Results of Independent Testing of SFEI's Multibox Model for PCB Fate and Transport

Prepared For:
Clean Estuary Partnership

Prepared by:
 Tetra Tech, Inc.
Lafayette, CA

September 2, 2005

Figure 7. Total PCB concentrations versus depth in sediments in San Pablo Bay.

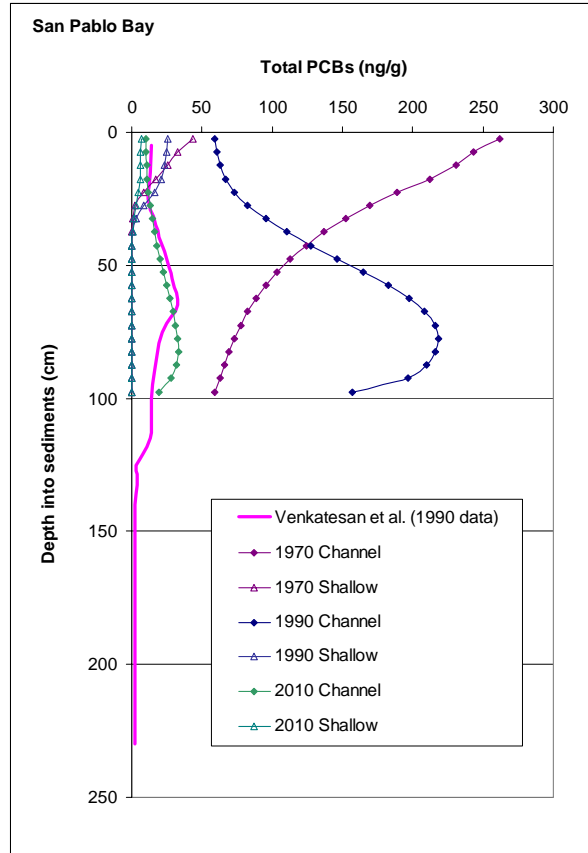
9. A number of other miscellaneous suggestions are provided throughout the report. They are:
 - Discuss why the two modeled PCB profiles for 1970 and 1990 differ as much as they do (see Figure 7).

While this equation was not rigorously verified, units were checked and found to be consistent throughout. As an additional check, several time-variable depth profiles of PCBs in the sediments were plotted and visually evaluated. An example for San Pablo Bay is shown in Figure 7. Focusing on the 1970 and 1990 channel profiles, it appears that those two sediment profiles differ significantly over depth, considering that they represent predictions that are only 20 years apart. An explanation of whether these differences are plausible should be provided.

2) (pages 26-27) - I can make a more detailed presentation of the sediment mixing equations in the next report. Regarding whether or not I think the change in profiles over 20yrs is reasonable... A purely diffusional timescale to move 50cm into the sediment profile is on the order of 30-35 years (given $D_b \sim 70 \text{cm}^2/\text{yr}$). Add deposition (which it appears like this core represents) and the mass could move more quickly.

Figure 10. Time series of hindcast and forecast suspended solids concentrations at Freeport used by MBM.

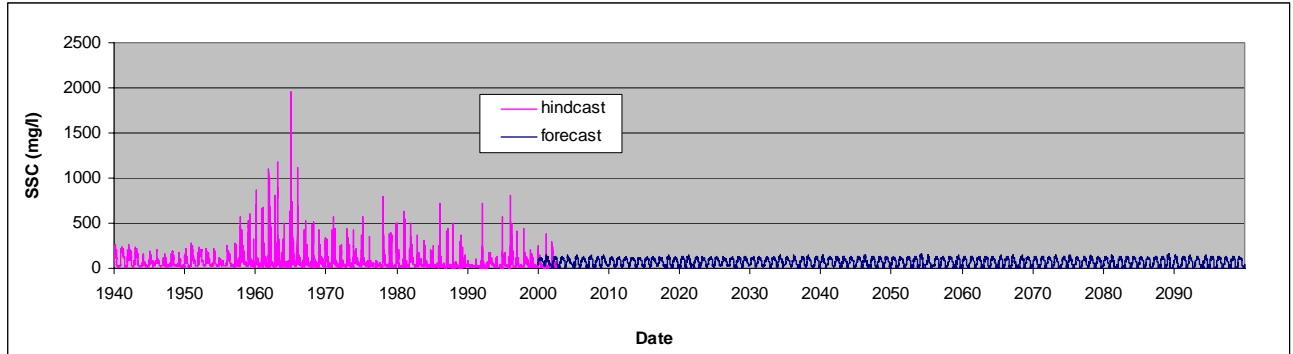
The hindcast and forecast suspended solids data at Freeport are shown in Figure 10. The suspended solids concentrations have close to the same mean values, as expected, but the variability in the forecast data series is lower (see Table 3).

Figure 11. Time series of hindcast and forecast evaporation rates used by MBM.

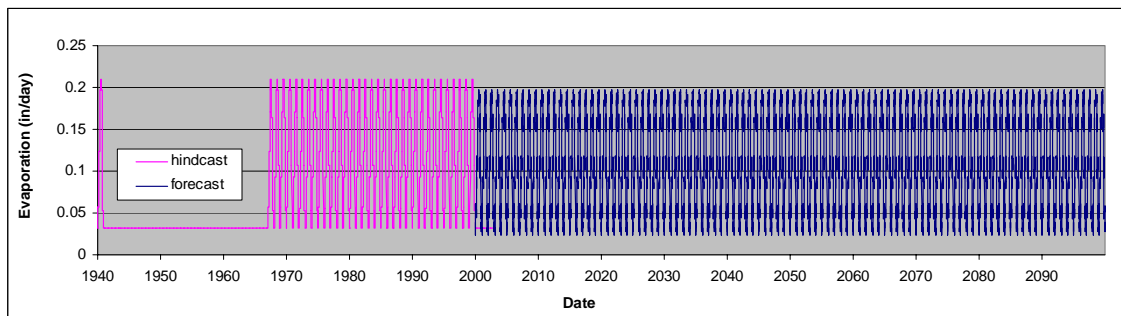
Figure 11 shows the time series of hindcast and forecast evaporation rates from the Bay. Two anomalous conditions are illustrated: the 30-year period of missing data early in the hindcast, and the small but apparent shift in evaporation rate at the interface of the hindcast and forecast periods. Both of these issues should be addressed. Additionally, recent studies have shown that the state will warm over the 21st century due to increasing greenhouse gas concentrations (Knowles and Cayan 2002; Hayhoe et al. 2004). Ultimately the increased surface temperatures could lead to increased water temperatures, which could affect evaporation of Bay water, which in turn could influence circulation in parts of the Bay where residence times are large, such as Lower South San Francisco Bay. Figure 12 illustrates the possible influence of increased water temperatures on evaporation. For water temperature increases in the range of 1 °C to 5 °C, evaporation losses can increase by 5 percent to 40 percent.

Andy sent you my CEP Powerpoint, which can serve as my response to the SSC problems. We have added the missing evaporation data. Thank you for your helpful comments, Dave

Figure 14. Relative sea level at Golden Gate, 1850 - present.

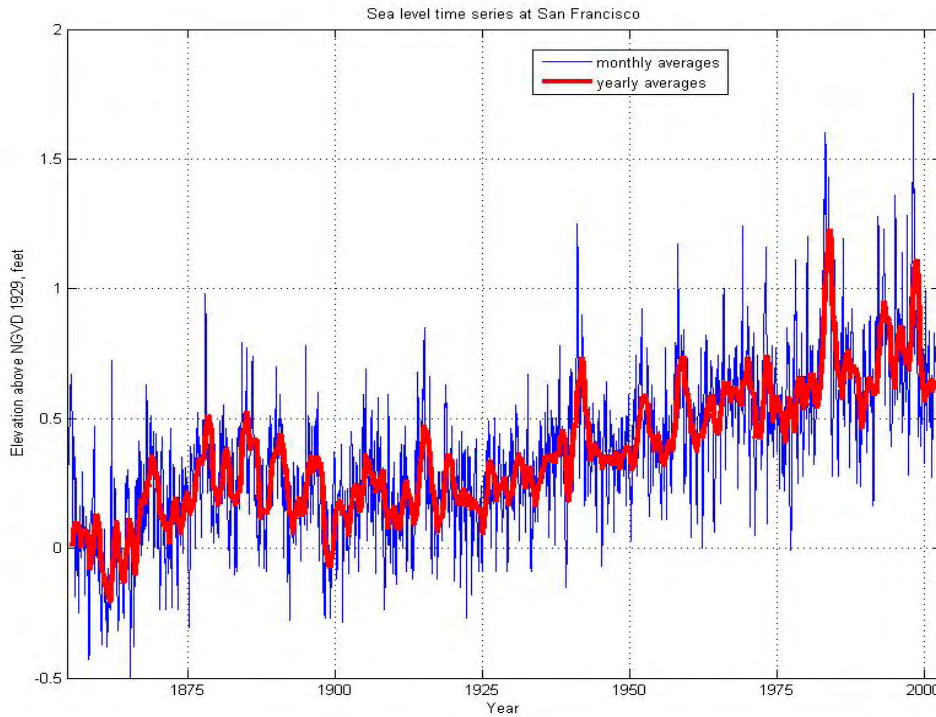
4. The possible impacts of sea level rise at the Golden Gate on PCB flushing from the Bay within the 21st century (the time frame of the forecast period) should be evaluated.

The tidal state (TS) time series for the hindcast and forecast periods is shown in Figure 13. TS is used as input to the UP model (Uncles and Peterson 1995, 1996) that calculates salinity distribution throughout the estuary. TS is a dimensionless parameter whose magnitude varies by tidal amplitude. At the Golden Gate, de-trended water level data are used to calculate TS (Uncles and Peterson 1996) and it does not appear that the effects of future sea levels are considered. The historical sea level data at the Golden Gate clearly shows an upward trend over the past 100 years (Figure 14). Model predictions groups indicate that sea level rise over the 21st century could accelerate (Hayhoe et al. 2004). For example, the relative sea level rise at the Golden Gate during the 20th century was approximately 13 cm. Towards the end of the 21st century, the sea level could increase another 19 to 41 cm (Hayhoe et al. 2004). The work of Knowles and Cayan (2002), which applies the UP model to San Francisco Bay to evaluate the effects of global warming on the Bay, indicates that higher salinity levels will exist in the Bay. It is suggested that the UP Model be tested over different periods within the forecast period to examine the effect of increasing sea level.

Figure 17. Time series of predicted suspended solids concentrations in boxes 3 and 37 illustrating the “Spin-up” Period.

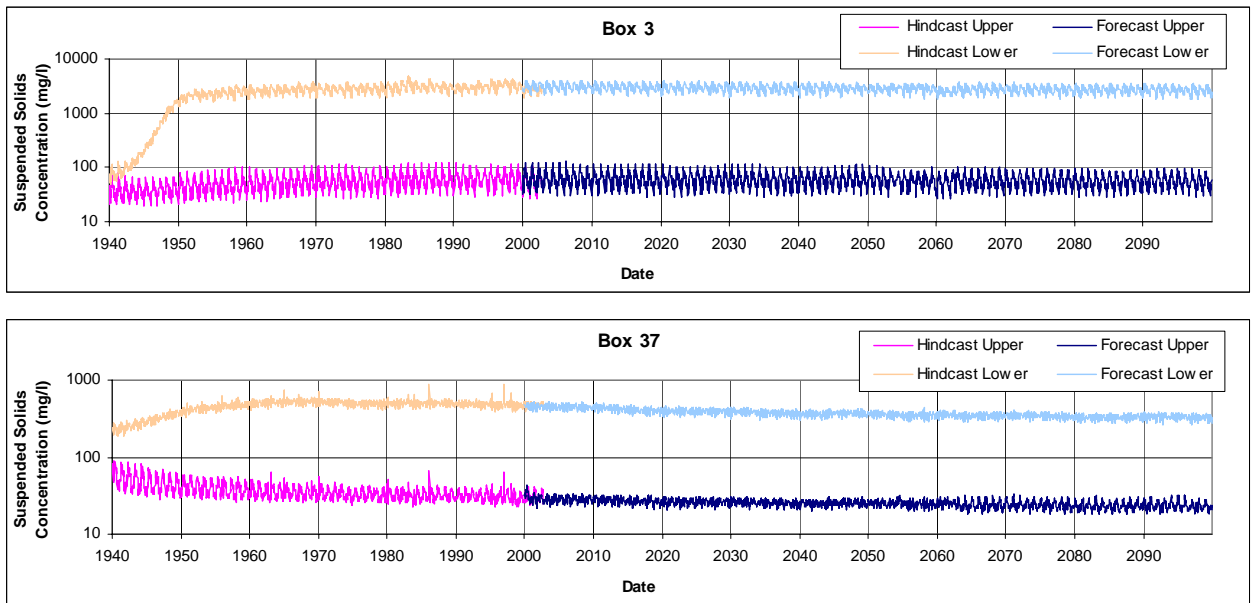
The hindcast period began in 1940, for which model initial conditions were developed. The initial conditions include PCBs in bedded sediments, which were set to zero. As the model simulations proceed onward from 1940, it appears that the Bay's suspended solids undergo an adjustment period of a decade or so, as shown, for example in Figure 17. This is typically called a spin-up period, and is often unavoidable because actual initial conditions are not known. It is possible to remove the influence of the spin up period by either initializing the model earlier in time and ignoring the spin-up period in terms of reporting results, or delaying PCB loads into the Bay until after the spin-up period. For this modeling application, PCB loads were added during the spin-up period and could result in unrealistic PCB transport during that time period.

Also, in 1940 PCBs had already been discharged to the Bay (from as early as 1927) according to the Breivik curve analysis reported in the draft report. By about 1940, the loading of PCBs exceeded today's loading rates by about 20 times (as shown later in Figure 30), so the assumption that the sediments were free of PCBs in 1940 is not consistent with the Breivik curve approach.

Alternative choices exist for how the model is initialized. One choice, for example, would be to initialize the model to the year PCB discharges to the Bay were thought to have begun (1927). For that starting time it would be appropriate to initialize the sediments as

4) Model Initialization (pages 42-44) - I agree there are issues with initialization in both the hindcast and the forecast. The hindcast represents a very different problem, as it involves model spin-up. We can change the start date for the hindcast model. However, it is currently calibrated so that net sedimentation during 1951-1983 matches observations (if I remember correctly). It may be best to start PCBs much later, maybe in the 90s, according to existing field data and then see how they get redistributed. I don't see the forecast as having the same spin-up issues. The spin-up problems seem to be minimized when the model is initialized with box volumes equal to those at the end of the hindcast.

Figure 18. Comparison of predicted and observed suspended solids concentrations in box 3 (model predictions are 14-day averages). UPS V.1 results are shown for reference (from Leatherbarrow et al, 2005).

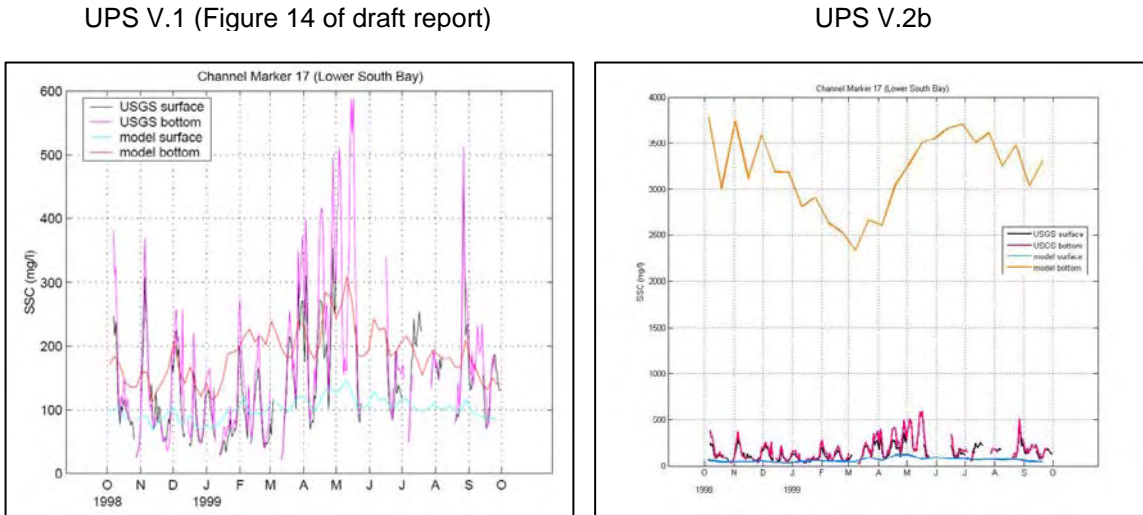
expected, the 14-day averages show less variability. At locations in the South Bay (Figures 18, 19, 20) the most noticeable features of the plots are the consistently higher model-predicted concentrations compared with USGS data. While some differences are expected, since the model predictions are volume averages, this behavior of higher predicted concentrations is consistent. This behavior is not observed, however, at Pier 24 (Figure 21) and Point San Pablo (Figure 22).

Figure 23. Year 1999 average and range of layer 2 daily predicted suspended solids concentrations at locations around the Bay.

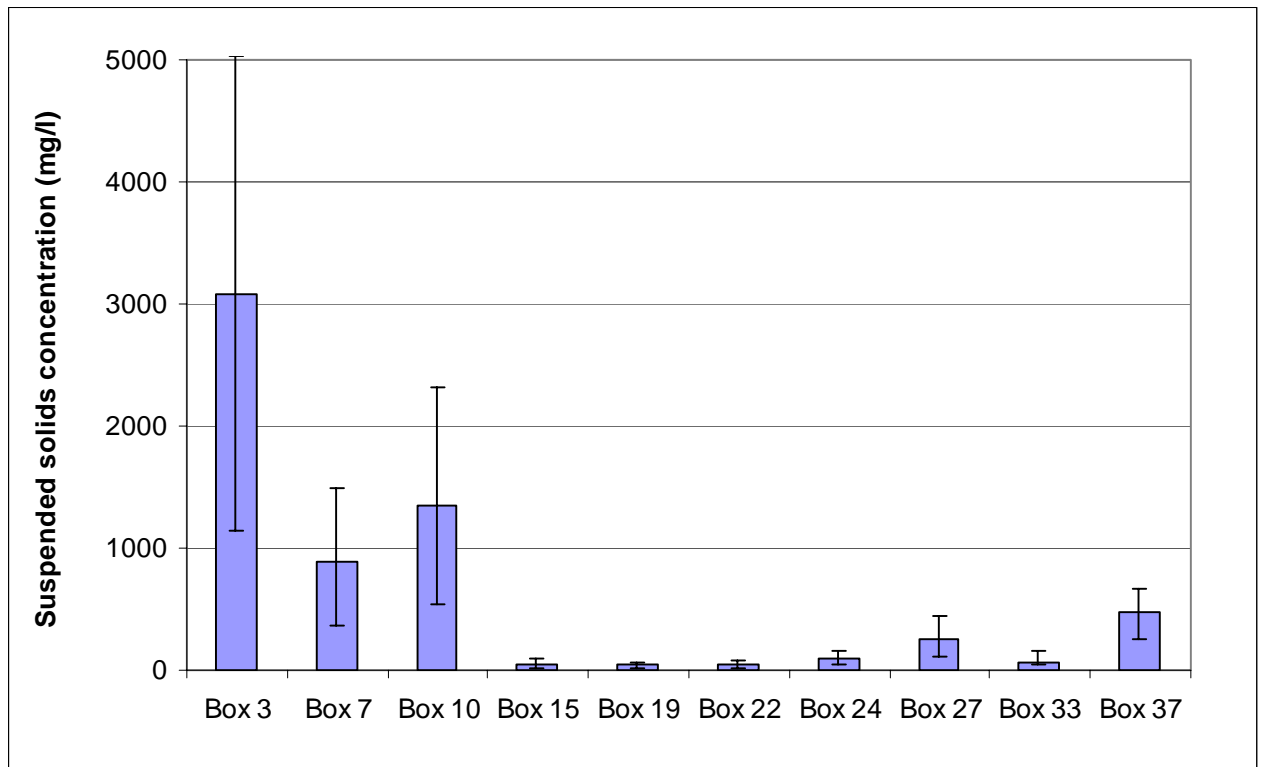
Figure 23 shows representative results for 10 boxes throughout the Bay, from Lower South Bay to Suisun Bay for the year 1999. These results again show high suspended solids concentrations in the South Bay, which dramatically decrease by box 15 in the Central Bay. It is suggested that implications of the high concentrations of suspended solids in the lower layer in the South Bay on PCB fate and transport be examined.

Figure 24. Bed elevation changes at selected locations in the Bay.

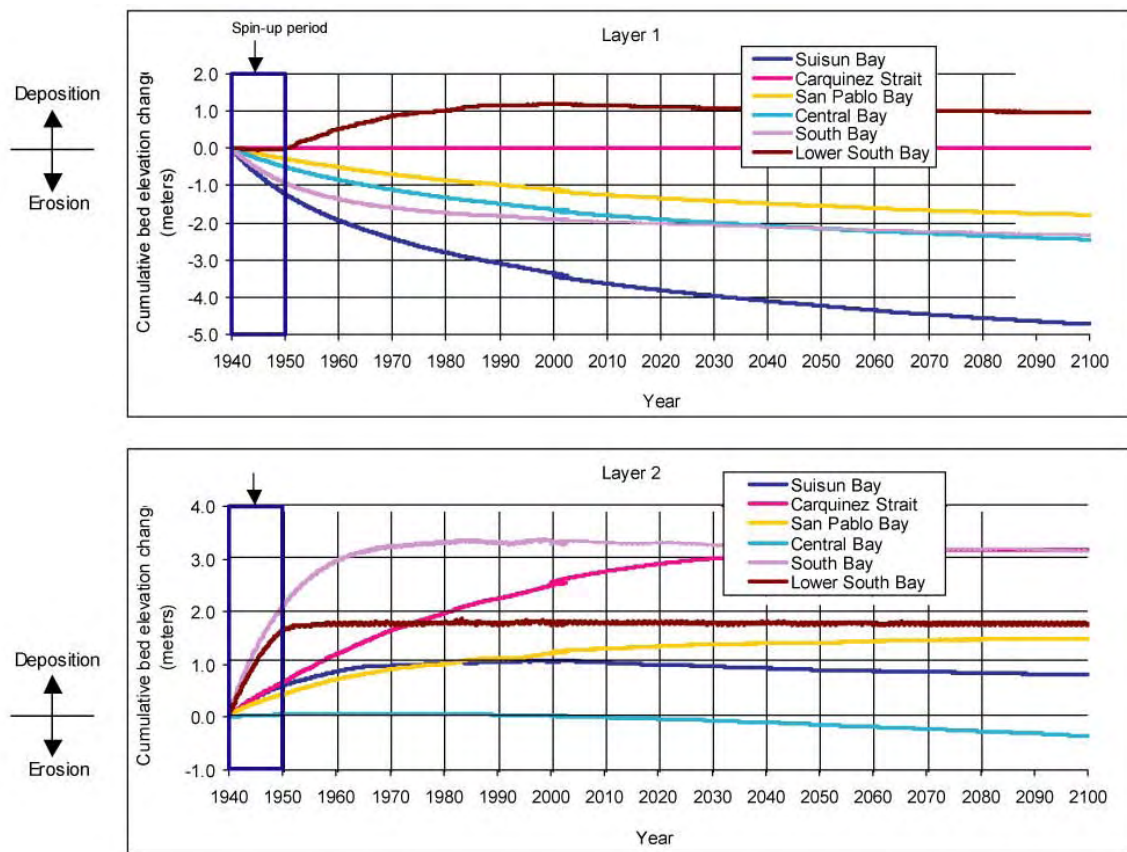
The second part of the UPS review focuses on predicted changes in bed elevations, and predicted cumulative amounts of erosion and deposition at locations where estimates have been made of sediment deposition and erosion. Figure 24 shows cumulative predicted bed elevation changes at six locations around the Bay, from Lower South Bay to Suisun Bay. The feature that is of most interest here is the rapid changes that occur during the first ten years or so following the beginning of model simulations. These rapid changes appear to be a manifestation of model adjustments to the initial conditions, as it appears that the model predicted bed elevation changes are much more gradual later in the simulations. This suggests, as discussed earlier, that if this phenomena is model-generated and not a feature of the Bay, that an adjustment in the spin-up period should be made to prevent this from impacting model predictions.

Figure 27. Comparison of observed data to MBM-predicted total water column PCB concentrations over hindcast and forecast periods.

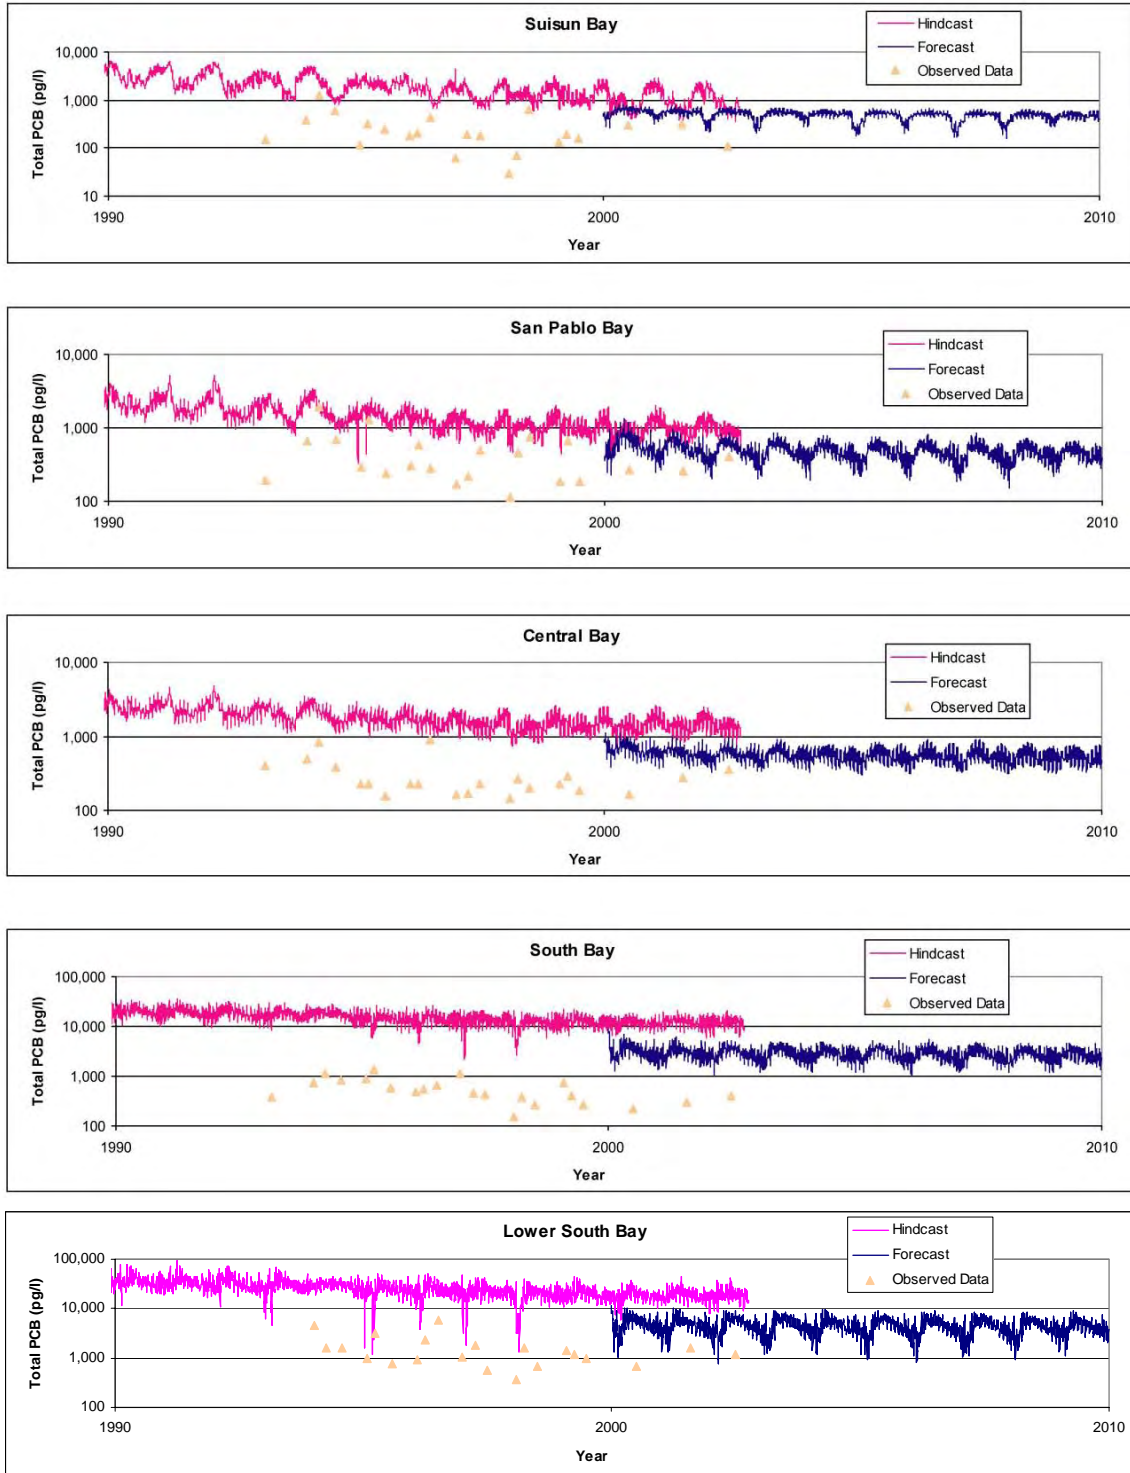
In this section, comparisons are made between observed and predicted PCB concentrations in the water column (both total and dissolved) and in the sediments. The results appear to show that the predicted concentrations in both water and sediments generally exceed observations. To illustrate this, Figure 27 shows the predicted one-day average total PCB concentrations during the hindcast and forecast periods, along with the mean of observed data. Locations shown are for Suisun Bay, San Pablo Bay, Central Bay, South Bay, and Lower South Bay. In all cases, the hindcast predictions exceed the observations, typically by a factor of 5 to 10 times. The figures also illustrate the scaling that was performed in the surface sediment for the forecast to bring the predictions into agreement with observed data.

Figure 28. Comparison of Year 2000 measured and predicted PCB concentrations – dissolved and surface sediment.

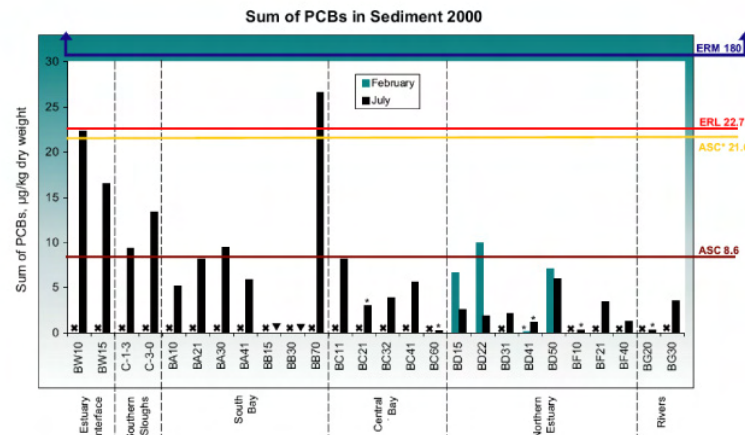
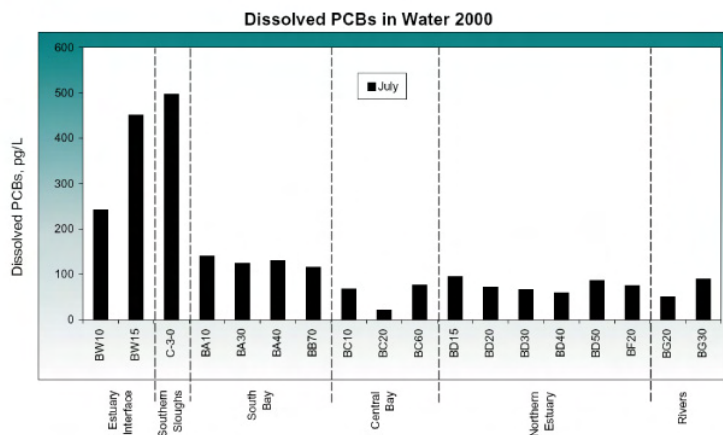
Figure 28 shows predicted dissolved water column PCB concentrations for year 2000 at three locations (Lower South Bay, Central Bay, and San Pablo Bay) for both upper and lower layers, and RMP data for comparison. The predicted values exceed observations by about 3 to 10 times. In the surface sediments, the same results apply, where higher than observed surface PCB concentrations are predicted. A depth profile of sampled PCBs in 1990 (from Venkatesan et al, 1999) was plotted against predicted profiles for 1970 and 1990 (see Figure 29). Based on the bathymetry of San Pablo Bay, the 1990 profile is located in the channel; it exceeds the observed profile data by 5 to 10 times. It is noted that the predictions for 2010 in the channel match the data for Venkatesan et al. (1999); because of the scaling, these data more closely match observed data. It is suggested that the need for this scaling be eliminated by determining the cause of the generally elevated predictions for PCBs. One cause could be that in the model, larger historical PCB loadings are input to the Bay than actually occurred (see the following section).

Figure 31. Total PCB loads to Bay based on approach from V.1 draft report.

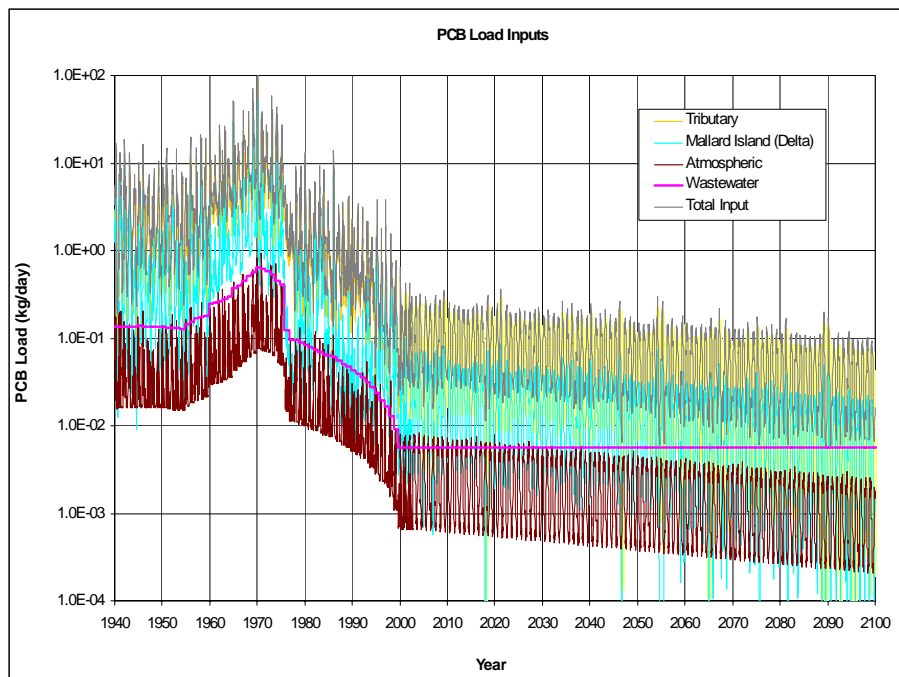
- PCB loading to the Bay by 1940, according to Figure 31 was quite large, perhaps an order of magnitude greater than today. Thus, it is likely that there would have been significant quantities of PCBs in the Bay by then. Thus, setting sediment PCB levels to zero in 1940 is probably not realistic.
